CITY PLANNING DEPARTMENT

May 8, 1980

- SUBJECT:
1. Request to establish a PUD Designation
 2. Request to designate a PUD Schematic Plan for office and open space (P-8970)

LOCATION: East side of Freeport Boulevard, approximately 1,300 + feet north of River Bend Road

EXHIBIT A

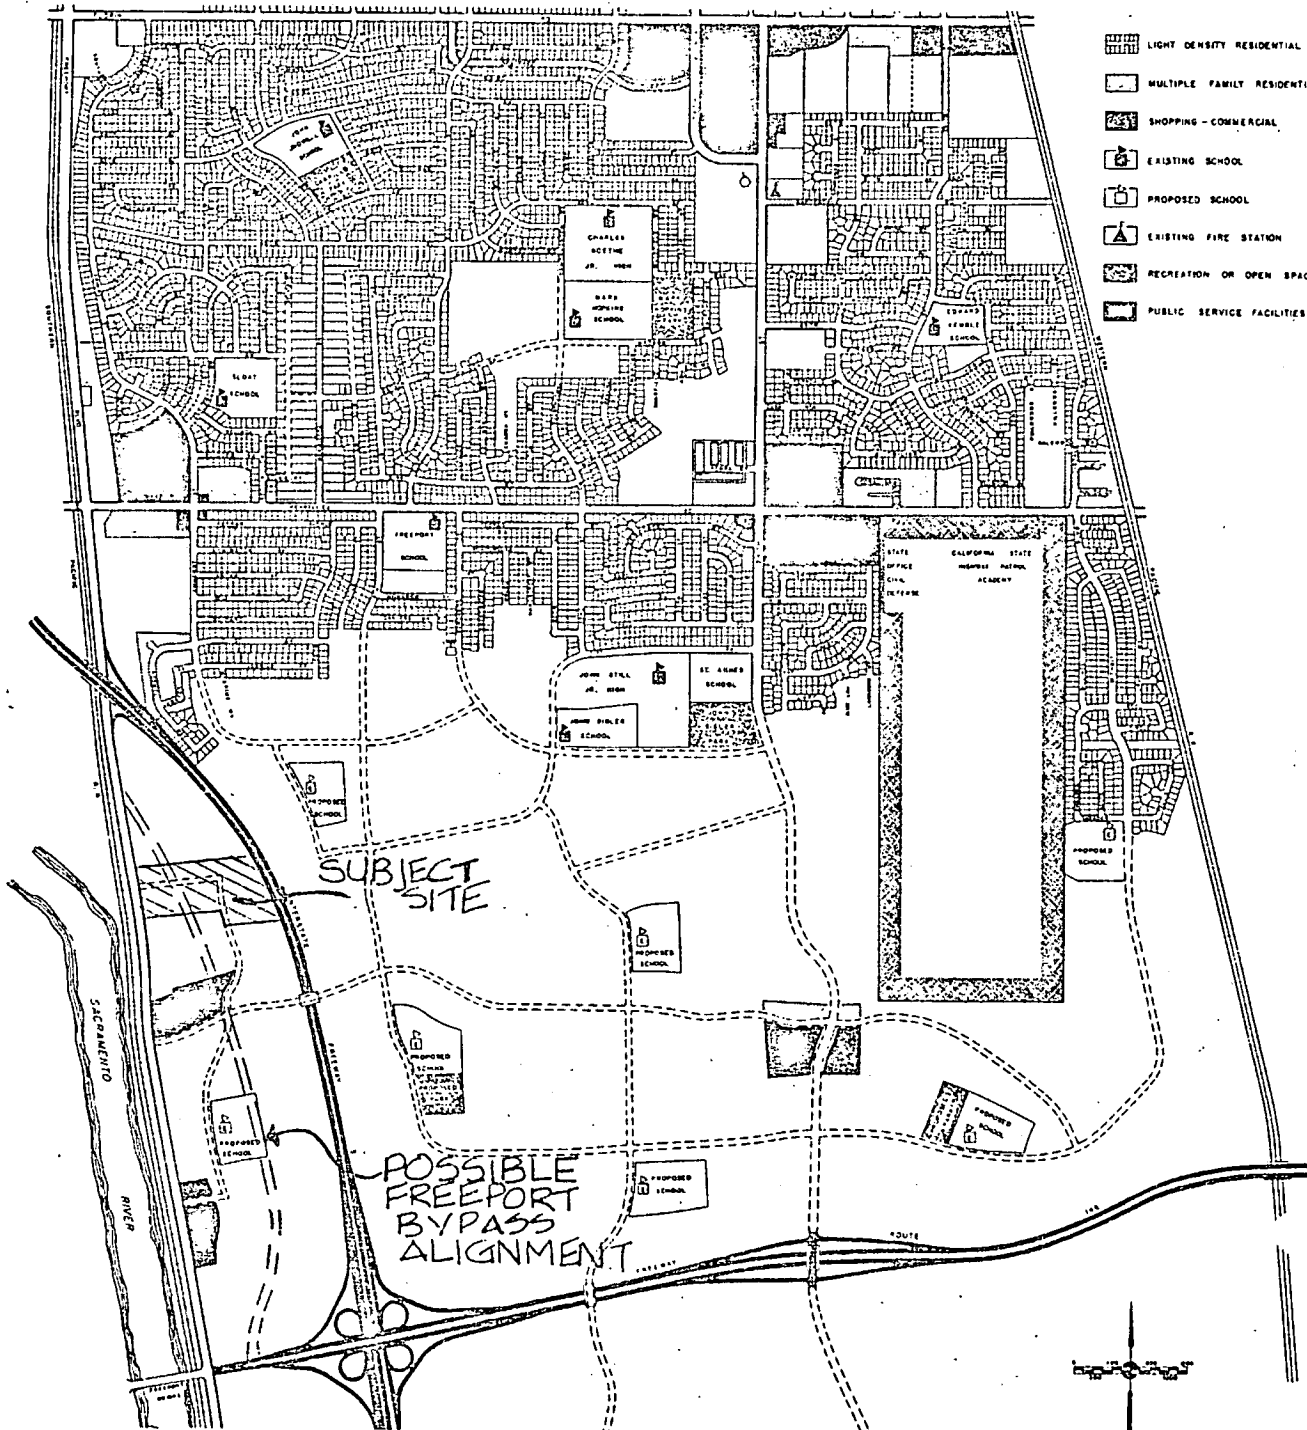
- *b. The developer shall provide a right-of-way easement for a north/south public street for possible future Freeport Boulevard bypass alignment as indicated by Exhibit A. The easement shall be 200 feet in width and comply with the City Traffic Engineers recommendation for a street right-of-way.

- b. *The developer shall provide for a right-of-way easement for a north/south public street for possible future Freeport Boulevard bypass alignment as indicated by Exhibit A. The developer shall provide an easement 200' in width in compliance with City Traffic Engineer's recommendation for the street right-of-way, said easement to be for a term of five years; and applicant shall enter into agreement with City under which the City shall determine the required right-of-way (80'-110'). Applicant shall dedicate street right-of-way within the five year period.*

EXHIBIT B

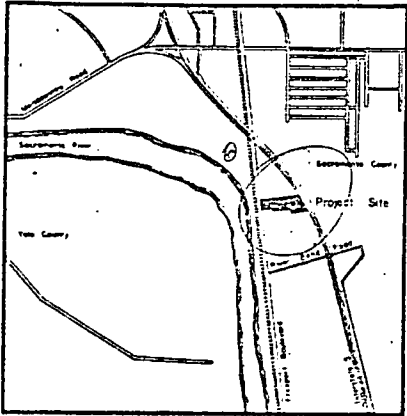
5. Private Roadway--The Fire Marshal recommends the private roadway be a minimum of 30 feet in width. In addition, the developer shall design a roadway that loops around the building or provide a paved area for fire trucks in order to allow fire equipment to be within 150 feet of all portions of the building. The loop road can therefore be deferred until the future building expansion is initiated providing the developer designs a temporary fire truck parking area as shown Exhibit B.

- f. The private roadway shall be a minimum of 30 feet in width. A loop roadway may be required around the structure when the future expansion is initiated. Temporary Fire Truck parking shall be provided as indicated in Exhibit B.

EXHIBIT C

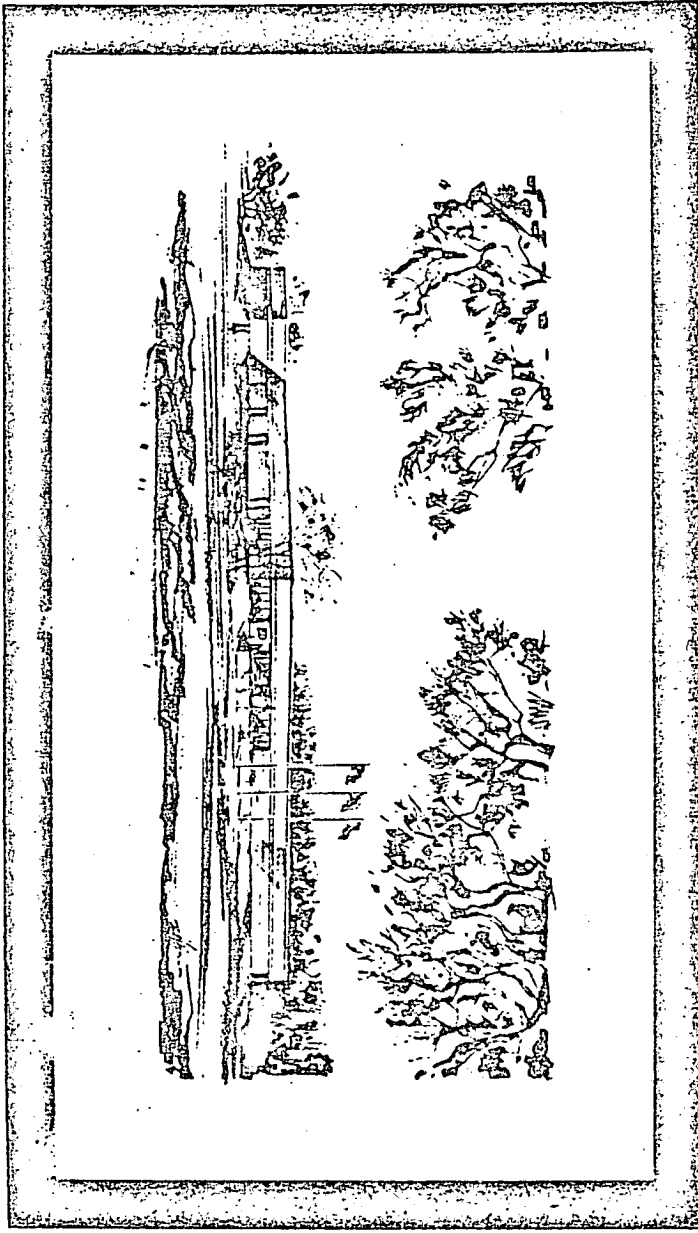
1. The Negative Declaration be ratified.
2. The subject 13+ acres be established as PUD for OB and A designations.
3. Approval of the PUD Schematic Plan for office building use (OB-PUD zone) on 6.515+ acres and agriculture use (A-PUD zone) on 6.814+ acres as indicated by Exhibit C.
4. Approval of the Special Permit request to develop an office building subject to the following conditions and based on findings of fact:

SECTION A-A

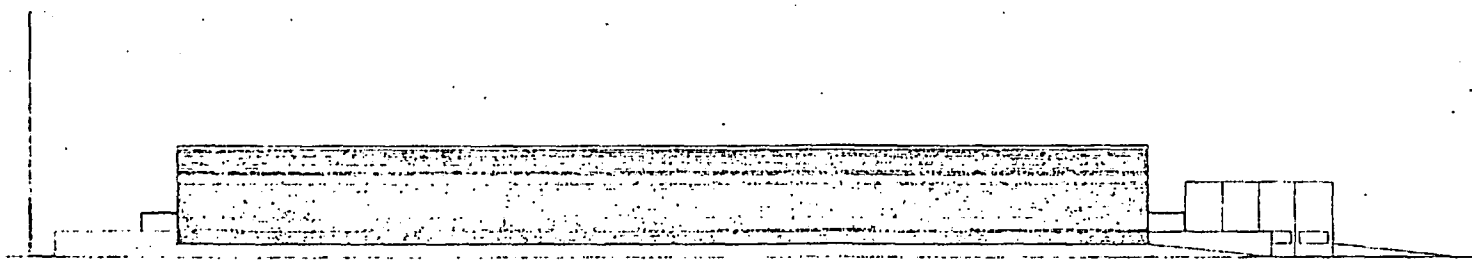
The east elevation contains exit doors, roll-up service doors and louvers for the mechanical-electrical rooms. Staff recommends these elements be painted a color that will compliment the brick veneer material.

The wall which screens the service yard and cooling towers (east elevation) shall also consist of brick veneer.

- 2). Minimum 15 gallon size evergreen trees shall be used in screening the satellite earth station.
- j. The exit doors, roll-up service doors and louvers on the east and north elevations shall be painted an earth tone color to compliment the brick veneer.

- *k. The wall material that screens the service yard and cooling towers (east elevation) shall consist of brick veneer.
 - 1. The window frames on all elevations shall be bronze anodized aluminum frames.

- k. *The wall material that screens the service yard and cooling towers (east elevation) shall be a foreign textured concrete material of an integral color and shall be reviewed by the staff.*
